# Northsight Residential Healthcare

## 1<sup>st</sup> Review Responses

Case: 15-ZN-2022

April 2023

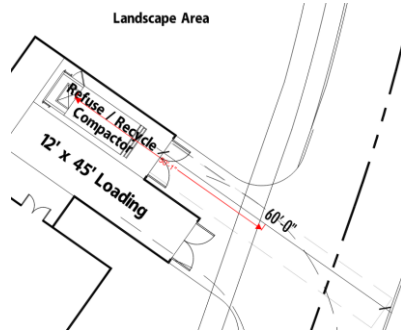
25. Page 5 – trip generation comparison should be limited to the existing land use or to a previously approved site plan.

- An updated traffic study has been included with this resubmittal, which includes a trip generation comparison to the existing land use.
